3.0 LAND USE AND ZONING COMMENTS AND RESPONSES

The following Land Use and Zoning comments (3-1A through 3-1J) relate to questions regarding the zoning code variances required for the DEIS Site Plan and the request to provide and discuss a Site Plan that requires no variances. Response are provided at the end of these comments.

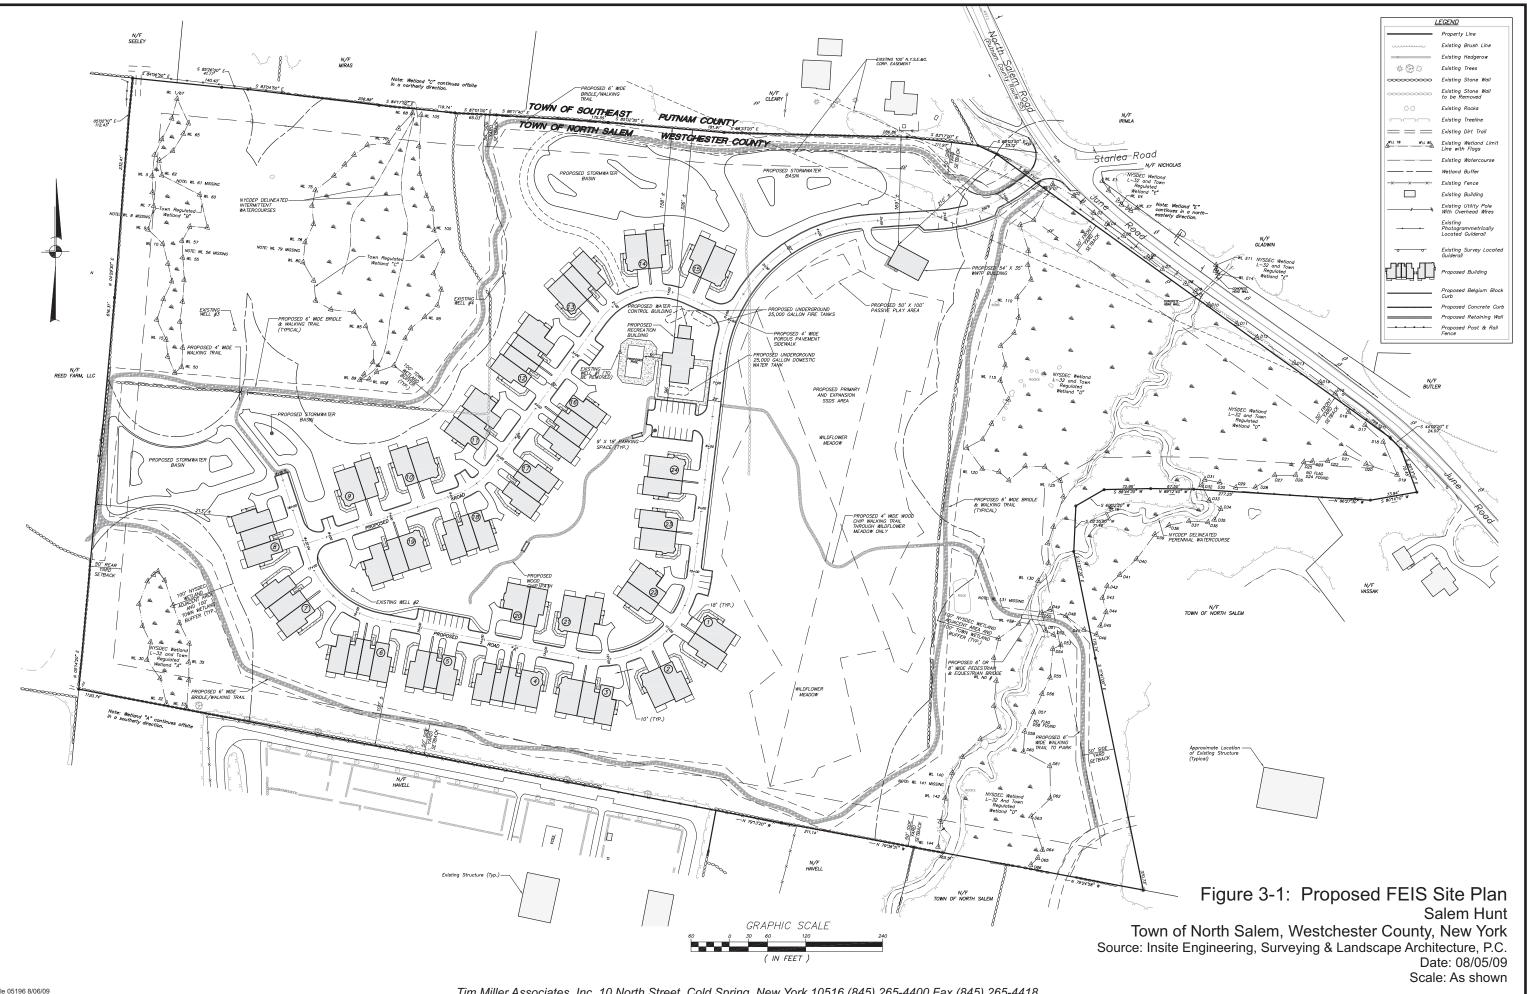
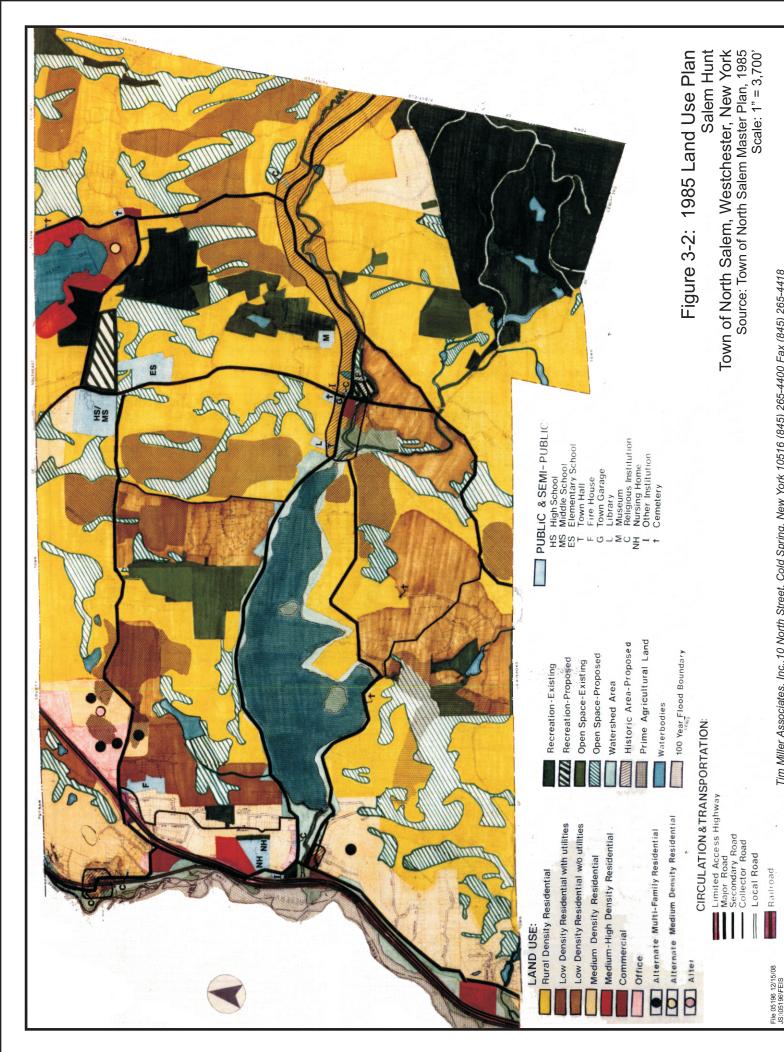
<u>Comment 3-15 (Letter #17 Hilary Smith & Joe Bridges, MDRA, July 30, 2008)</u>: The proposed "boulevard-style" entrance road's consistency with the neighborhood's prevailing rural character should be evaluated. Proposed changes to the site's June Road frontage with particular focus on the proposed site's access intersection should be further detailed and visually simulated/rendered. The materials presented should consistently address necessary clearing to achieve sight lines, the "boulevard-style" access and overall landscape treatment as viewed from the site's entrance.

Response 3-15: As described in Section 1.3 Summary of Proposed Action, the entrance into the project site has been revised and is now proposed as a two lane roadway with a pull off for parents to drop off their children for school bus pick up.

Currently, no signs, walls or extensive landscaping is proposed for the site entrance. Clusters of three flowering trees are proposed for each side of the entrance. The proposed landscaping for the project entrance is shown in Drawing SP 2.1 and 2.2 Layout and Landscaping Plan. No rendering has been done as the site plan and landscape plan clearly show the treatment of this area.
